Class II Permissive Change Letter

FCC ID:**XMF-MID1035**

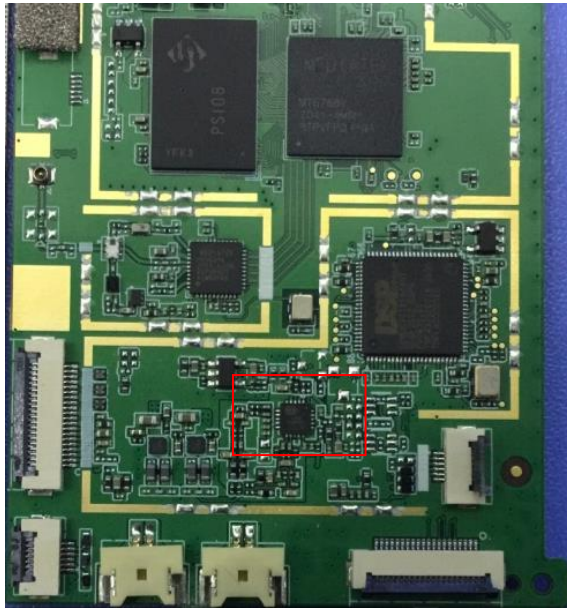
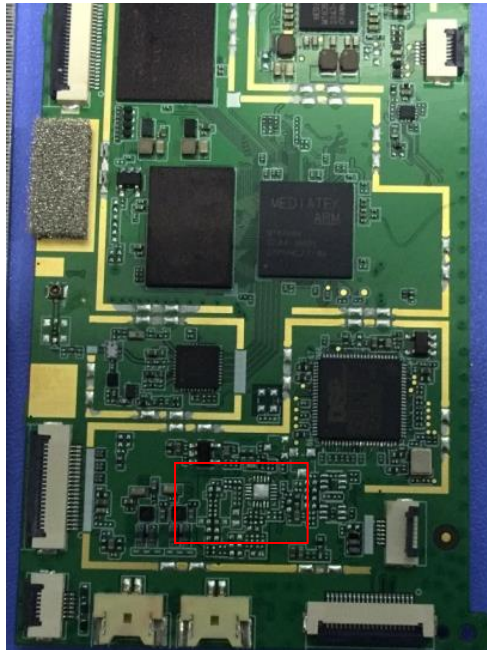
The new PCB delete the audio noise reduction **IC module(AC107)**.
